TOWN OF MOUNTAIN VILLAGE DESIGN REVIEW BOARD REGULAR MEETING

AGENDA ITEM 2 PLANNING & DEVELOPMENT SERVICE PLANNING DIVISON

RE: Discussion regarding a Conceptual Work Session for Lot 166AR2-10 to

RE: Discussion regarding a Conceptual Work Session for Lot 165, Unit 4 to

1 Parking Opt A-1

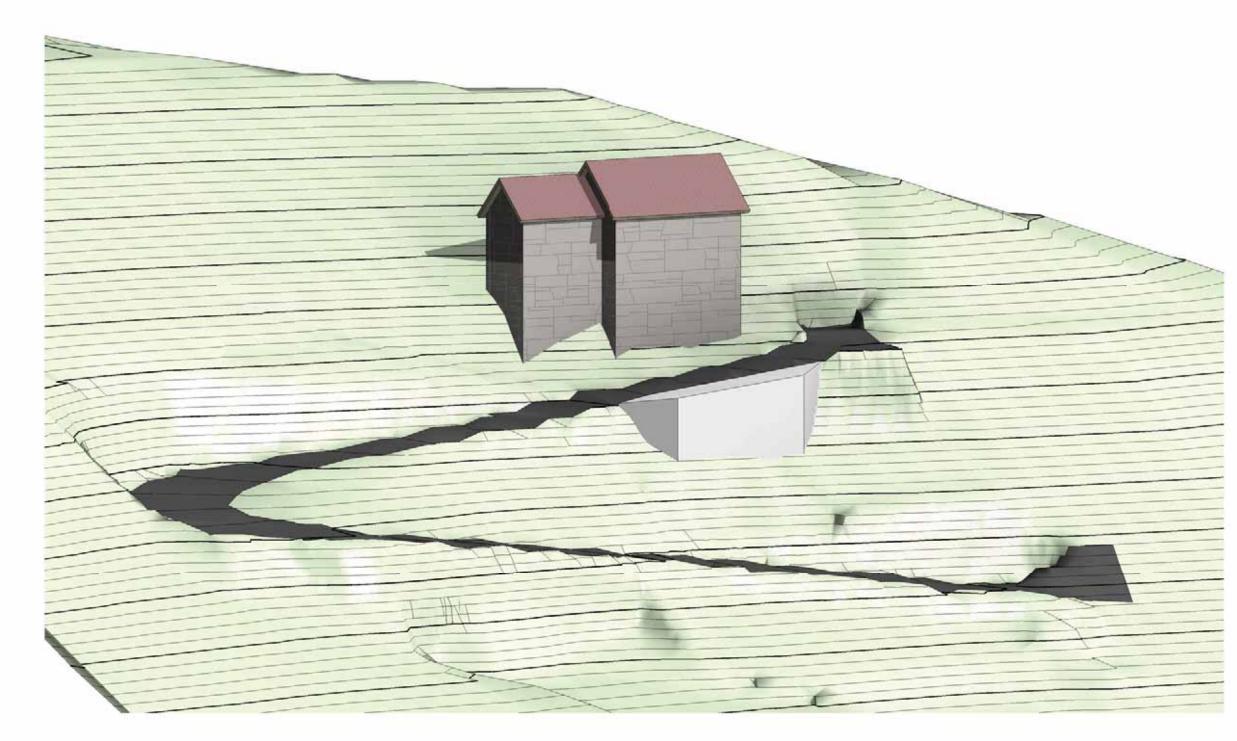
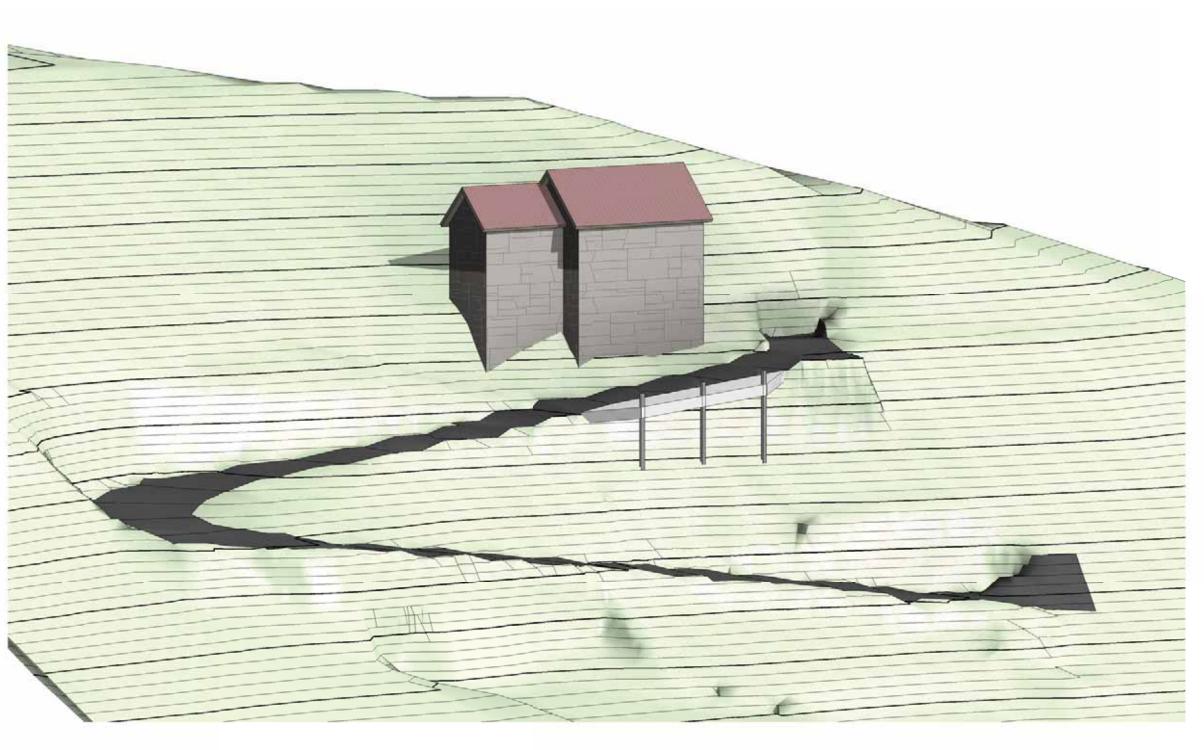
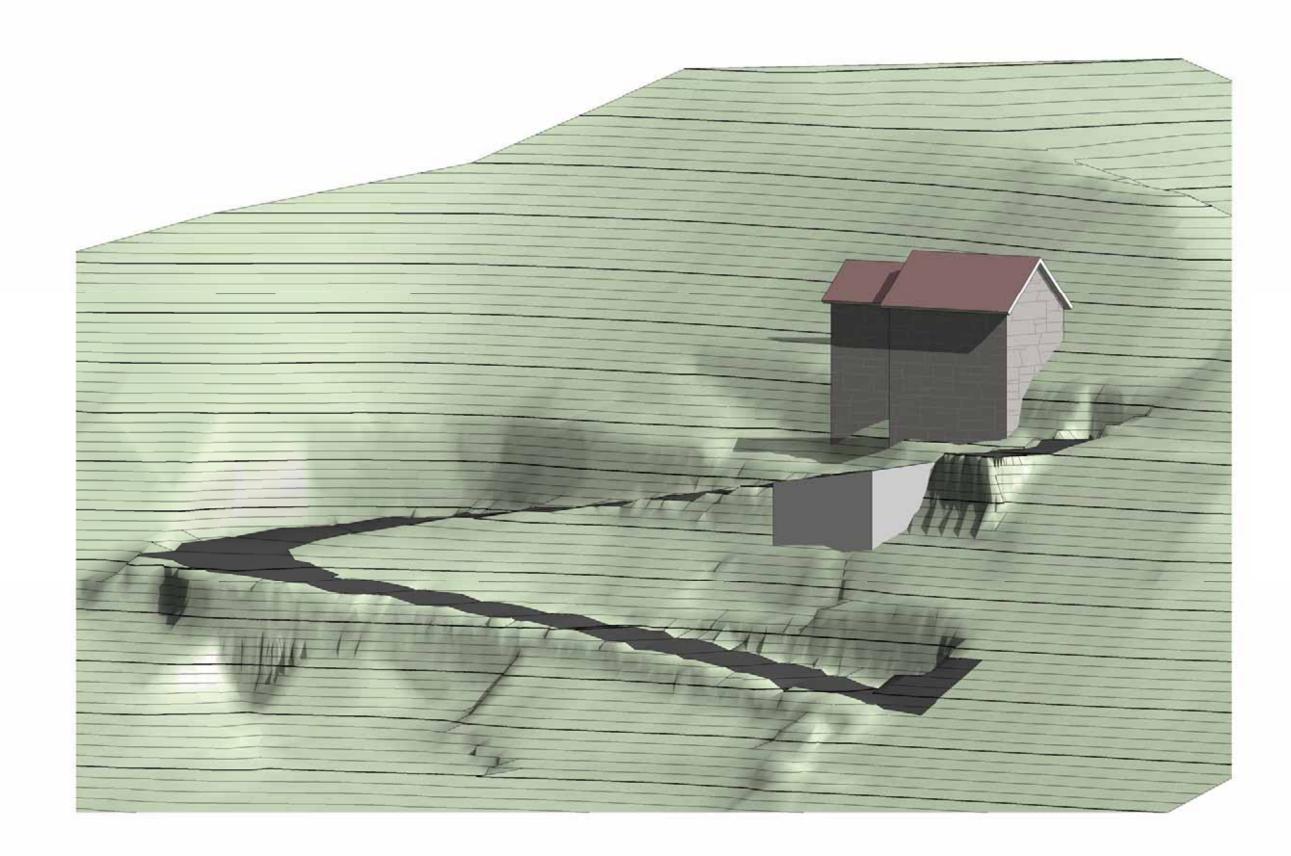
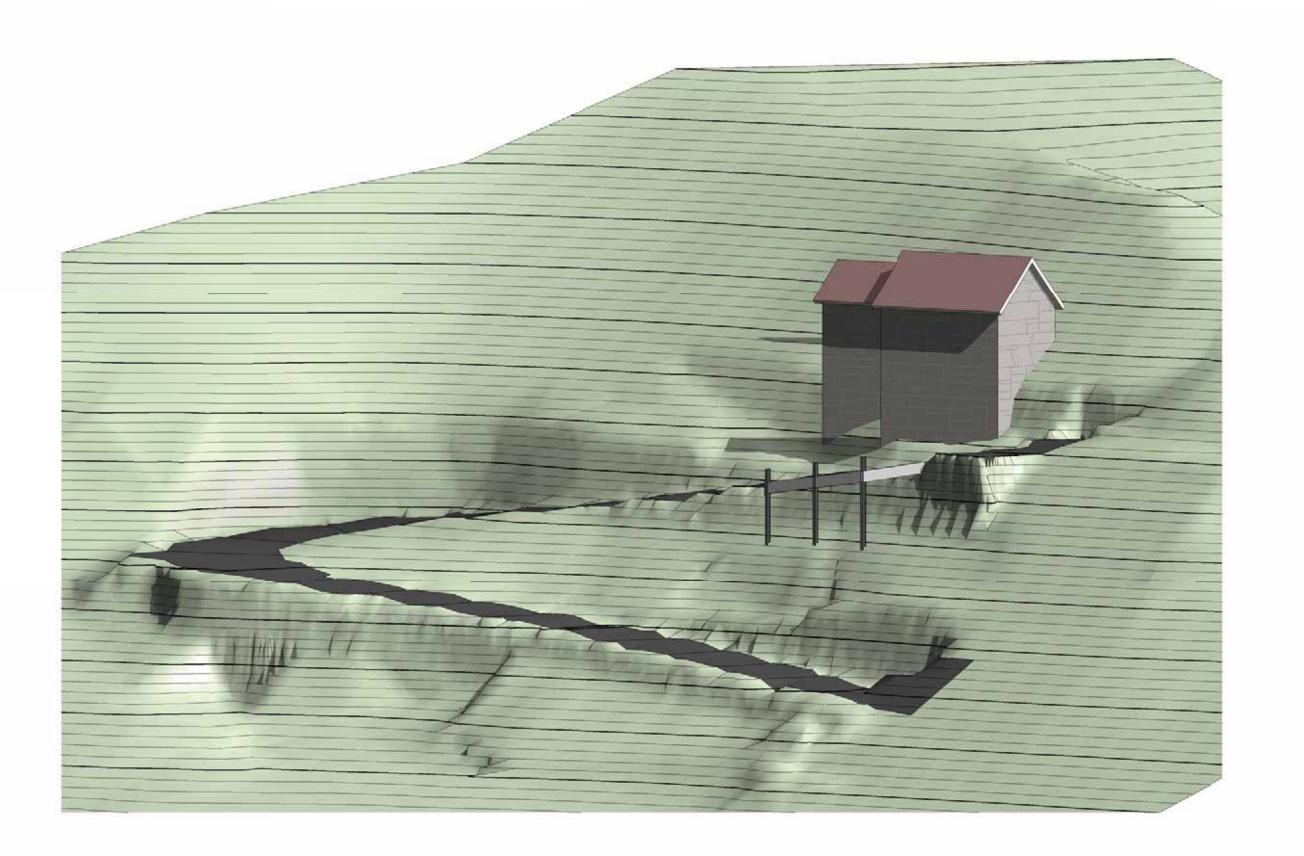
The focus of this work session is largely to discuss the DRB's thoughts on the various parking options. The applicant has shown (8) different options for a retained structure to the east of Stonegate drive, but still within the property lines, that could accommodate the two required exterior parking spaces. An alternative to building such a structure would be for the applicant to request and the DRB to grant a design variation waiving the requirement for those two spaces.

Although not a specific request of the applicant, staff has some concerns about this property as it relates to fire safety and would like to understand better how the applicant plans to accommodate a fire truck turn-around or otherwise provide a way to access the structure with hoses in case of fire.

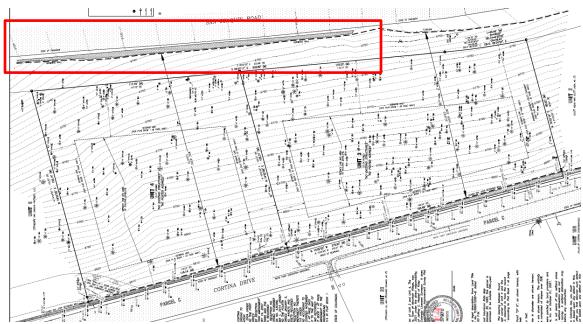
Although the plans are still at a work session level, it does appear that there will be Setback encroachments as part of this request. Note, that the Cortina units do not have a General Easement and rather relies on building setbacks established as part of the subdivision. The CDC intends that the setbacks are to be maintained in the same manner as the GE.

The site plan for Unit 4 identifies the following encroachments:

- 1. A portion of the suspended steel bridge (driveway access)
- 2. A portion of the concrete enclosure that supports the suspended garage

As the plans are still in conceptual format, there could be additional encroachments. The DRB should discuss these proposed encroachments and determine if these encroachments are appropriate.

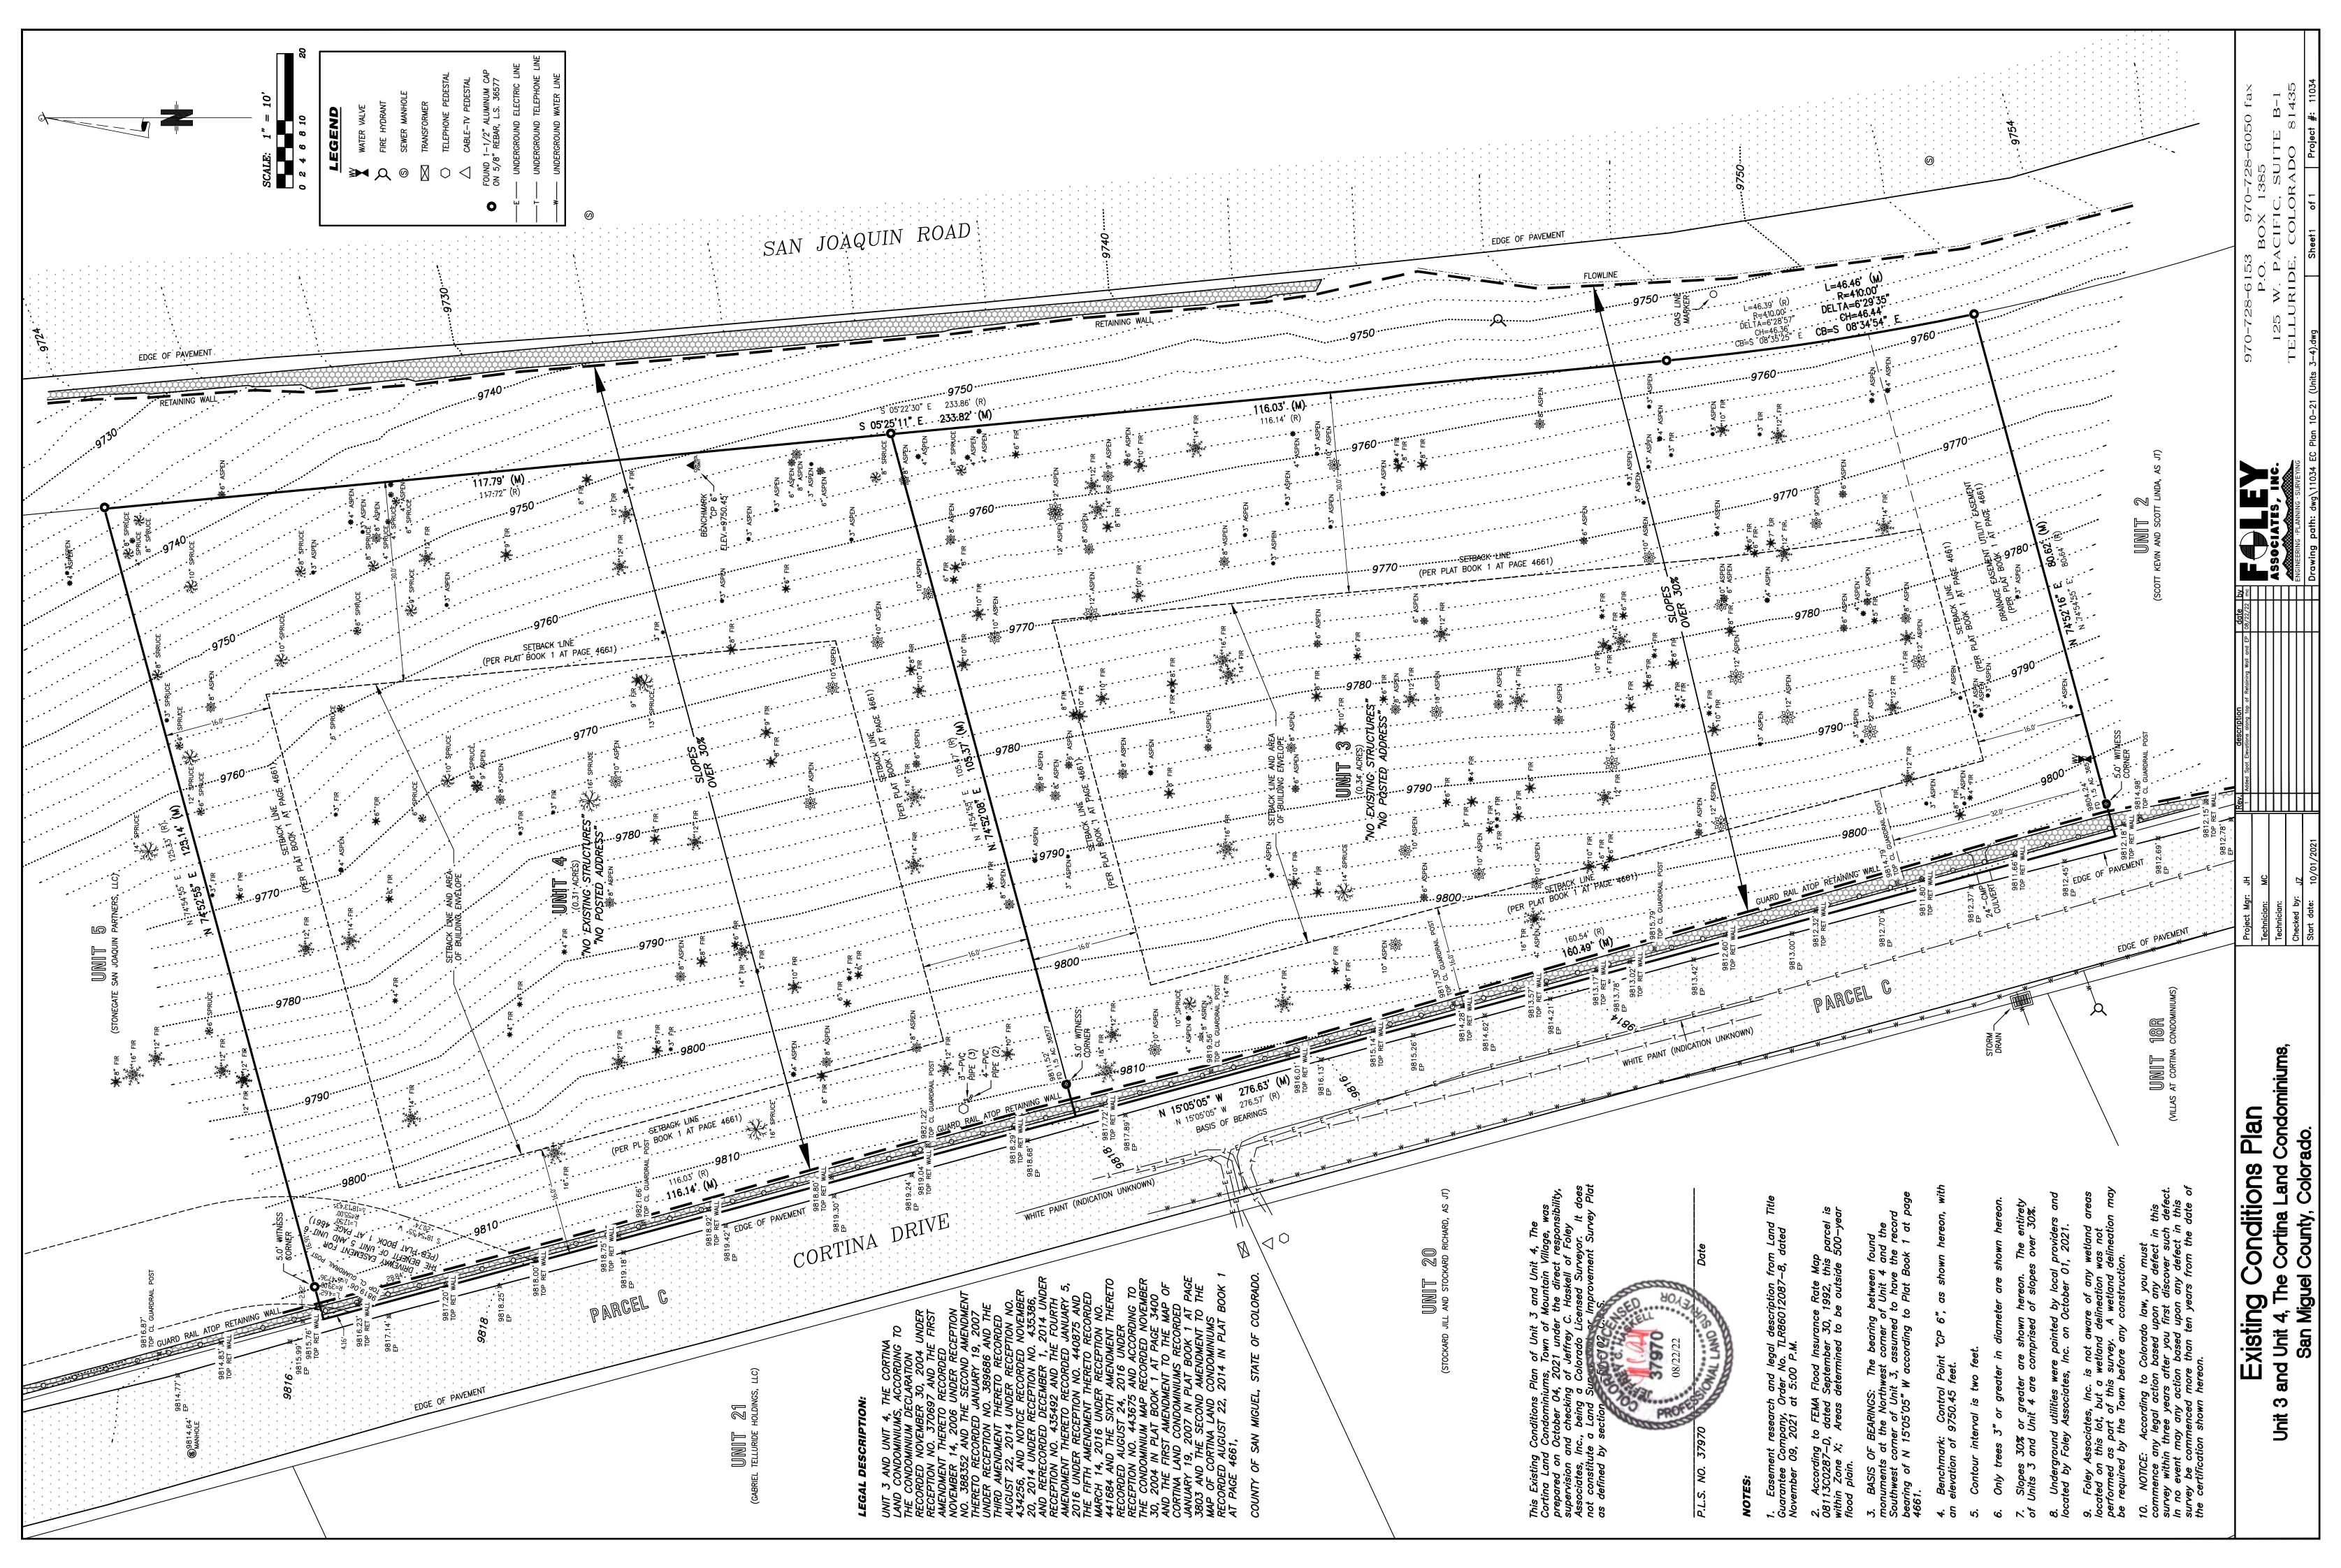
One additional consideration that should be discussed at this time is construction mitigation. Though a formal construction mitigation plan has not yet been submitted, given the constraints of the site, the building of this home is sure to present some challenges. The owner of this unit also owns Unit 3. Access to the lot from the downhill side seems necessary to construct. See the image below of Units 3 and 4:

The red rectangle indicates a retaining wall between the units and San Joaquin Rd. In order to access Unit 4 from below, you would likely have to enter off of Unit 3. Staff has concerns regarding potential traffic impact on San Joaquin Rd. as well as the necessity to revegetate any impacts on Unit 3, including potentially needing to replace trees removed for access. Staff asks that the applicant speak more to the plan for construction mitigation at the work session and that DRB give meaningful feedback as to potential solutions.
